PRODUCTION CHANGES IN CTC4 AND CTC4A

Circuit Diagram for Chassis CTC4, CTC4A

Chassis
CTC4
CTC4A

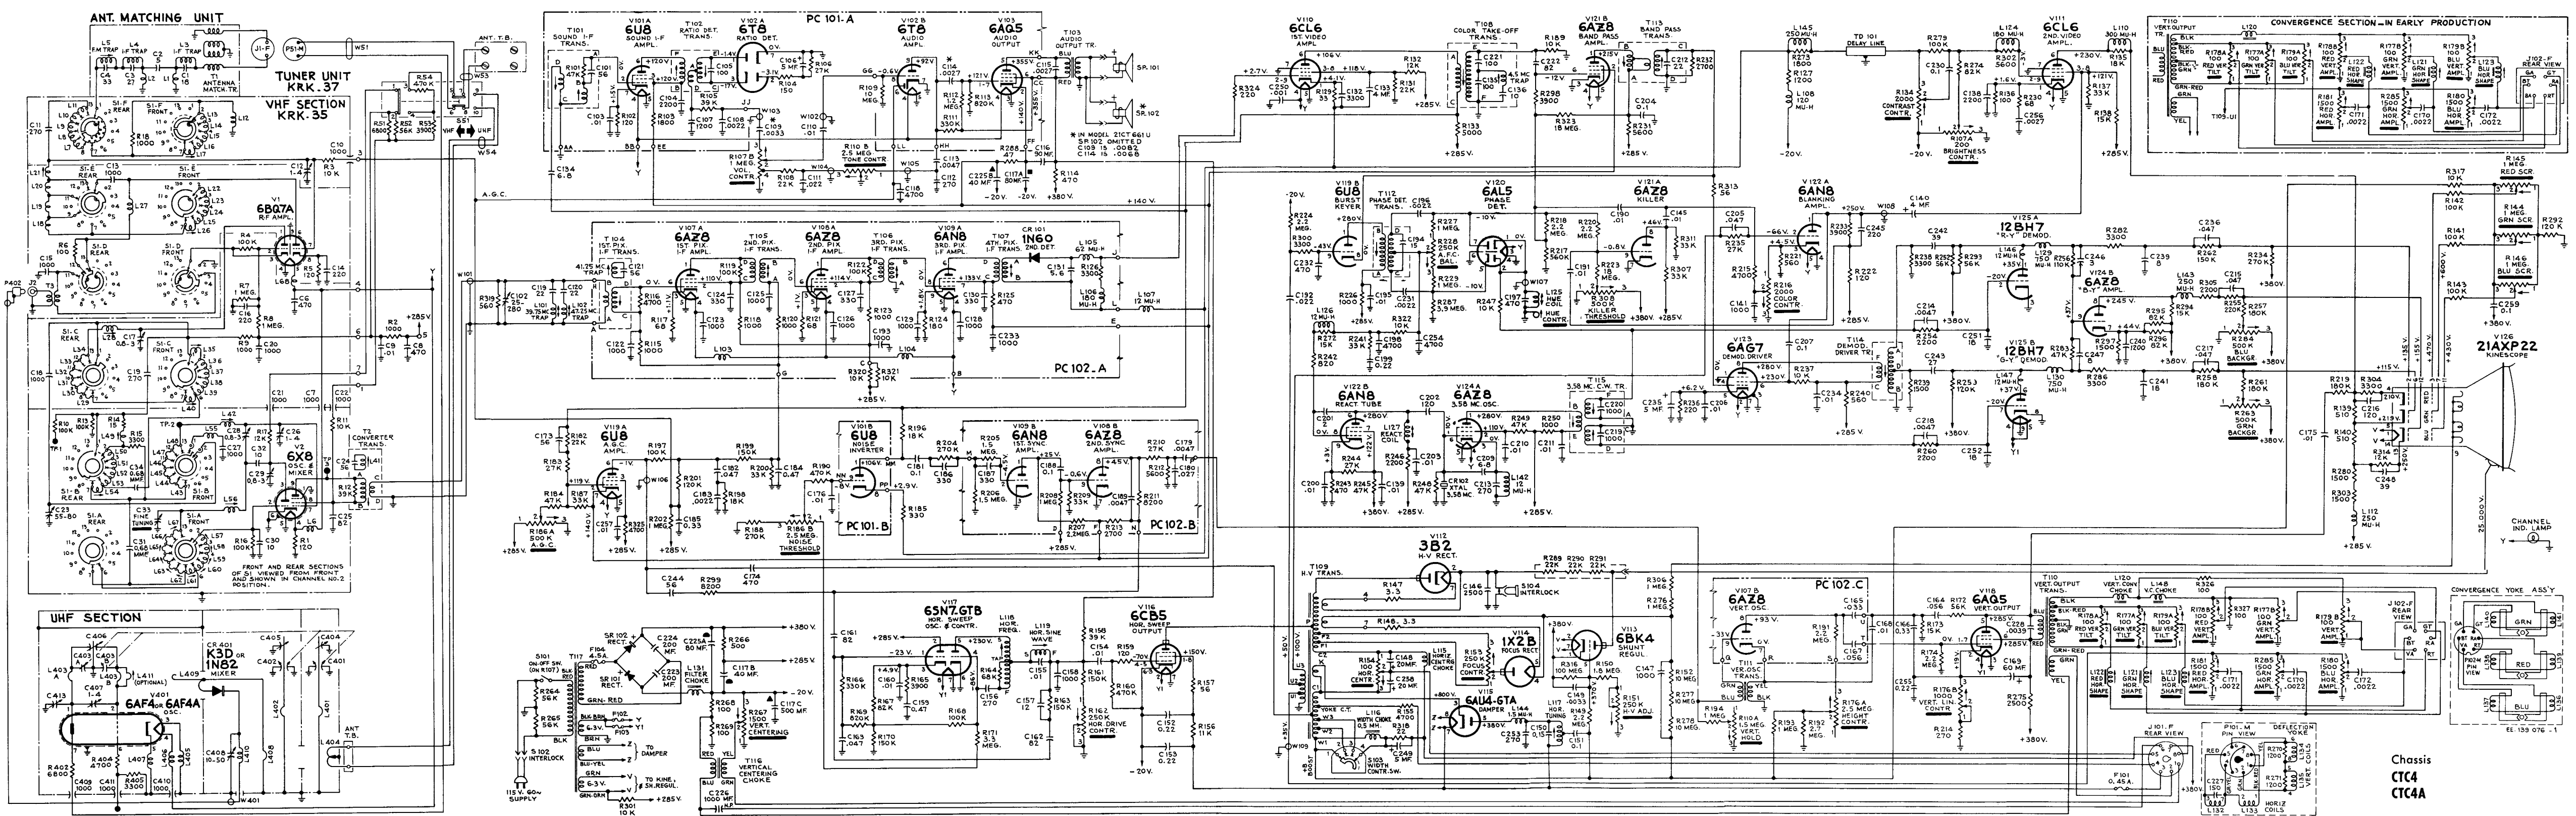
- In some receivers, a .082 mf. capacitor (C142) was connected from the green screen control (R144-2) to ground.
- In some receivers, a .082 mf. capacitor (C143) was connected from the red screen control (R145-2) to ground.

- In some receivers, a .082 mf. capacitor (C144) was connected from the blue screen control (R146-2) to ground.
- In some receivers, C148 across terminals 1 and 2 of R154, horizontal centering control, was 10 mf.

- In some receivers, a 10 mf. capacitor (C148A) was connected across terminals 1 and 3 of R154, horizontal centering control.
- In some receivers, C166, at terminal U of PC102, was connected to ground.

- In some receivers, C175, at pin 5 of V118, was .039 mf.
- In some receivers, C198, in grid circuit of V122B, was .01 mf.
- In some receivers, C215, in plate circuit of V124B, was .01 mf.

- In some receivers, C217, in plate circuit of V125B, was .01 mf.
- In some receivers, C236, in plate circuit of V125A, was .01 mf.
- In some receivers, C240, at pin 7 of V124B, was 270 mmf.

- In some receivers, C243, at terminal D of T114, was 39 mmf.
- In some receivers, C246, at pin 9 of V124B, was 2.0 mmf.
- In some receivers, C247, at terminal D of T114, was connected between the junction of R305/R255 and ground.

- In some receivers, C248, was .0012 mf., and was connected from the junction of L112/R314 to L111.
- In some receivers, C254, in grid circuit of V122B, was omitted.

- In some receivers, C255, at pin 2 of V118, was omitted.
- In some receivers, C256, at pin 1 of V111, was omitted.
- In some receivers, C257, at pin 3 of V119A, was omitted.

- In some receivers, C258 across terminals 2 and 3 of R154, horizontal centering control, was omitted.
- In some receivers, C259, between R146-3 and +385 volt buss, was omitted.

- In some receivers, a 62 microhenry coil (L111) was connected between C248 and C240 at pin 7 of V124B.
- In some receivers, a 1.0 MH coil (L128) was connected from pin 9 of V124B to the junction of R283 and R256.

- In some receivers, L129, at pin 1 of V125A, was 1.7 MH.
- In some receivers, L143, at pin 8 of V124B, was 1.7 MH.
- In some receivers, L148, at R177B-3, was omitted and R177B-3, R178B-3 and R179B-3 were connected to L120.

- In some receivers, R118, at pin 2 of V107A, was 10,000 ohms.
- In some receivers, R123, at pin 2 of V108A, was 10,000 ohms.
- In some receivers, R144, R145 and R146 (screen controls) were 500,000 ohms.

- In some receivers, R203, a 3.3 megohm resistor, was connected between R186, noise threshold control and the junction of R199, C182, R201 and R197.
- In some receivers, R230, at pin 1 of V111, was omitted.

- In some receivers, R231, at terminal A of T113, was 10,000 ohms.
- In some receivers, R232, across terminals C and D of T113, was 2,200 ohms.
- In some receivers, R234, at pins 2-9 of V110, was omitted.

- In some receivers, R256, at pin 9 of V124B, was 120,000 ohms.
- In some receivers, R259, in plate circuit of V125B, was 56,000 ohms.
- In some receivers, R276, in lead to V126-9 (kinescope), was 470,000 ohms.

- In some receivers, 56,000 ohm resistor (R281) was connected in parallel with R259 at V125B plate circuit.
- In some receivers, R283, at pin 9 of V124B, was 56,000 ohms.

- In some receivers, R292, at R146-1, was 56,000 ohms, 2 watts.
- In some receivers, R297, at pin 7 of V124B, was 2700 ohms.
- In some receivers, R306, in lead to V126-9 (kinescope), was 470,000 ohms.

- In some receivers, a 470 ohm resistor (R312) was connected between pin 6 of V116 and -20 volt buss.
- In some receivers, R314, at pin 13 of kinescope, V126, was 470 ohms and was connected between the junction L112/C248 and the -285 volt buss.

- In some receivers, a 180 ohm resistor (R315) was connected between the junction of C240/L111 and ground.
- In some receivers, R319, at T104 input, was omitted.

- In some receivers, R320 and R321, between terminal C of PC102 and +285 volt buss, were omitted.
- In some receivers, R322, in grid circuit of V122B, was omitted.

- In some receivers, R323, at terminal A of T113, was omitted.
- In some receivers, R325, at pin 3 of V119A, was omitted and V119A-3 was connected to +285 Volt.

- In some receivers, R326, at R179B, vertical amplitude control, was omitted.
- In some receivers, R237, at R177B-3, was omitted.
- In some receivers, terminal U1 of T109 was -70 volts.

- In some receivers, V111-4 was connected to Y1 instead of Y.
- In some receivers, V115 was a 6BL4.
- In some receivers, V121B-2 was connected to terminal A of T113.

- In some receivers, V125A pins 4 and 5 were connected to Y instead of Y1.
- In some receivers, the blu/yel lead of T117 was not connected to +380 volts and the blu lead of T117 was grounded.

- In some receivers, the convergence circuit was connected as shown in the small circuit shown at the upper right hand corner of the schematic diagram.
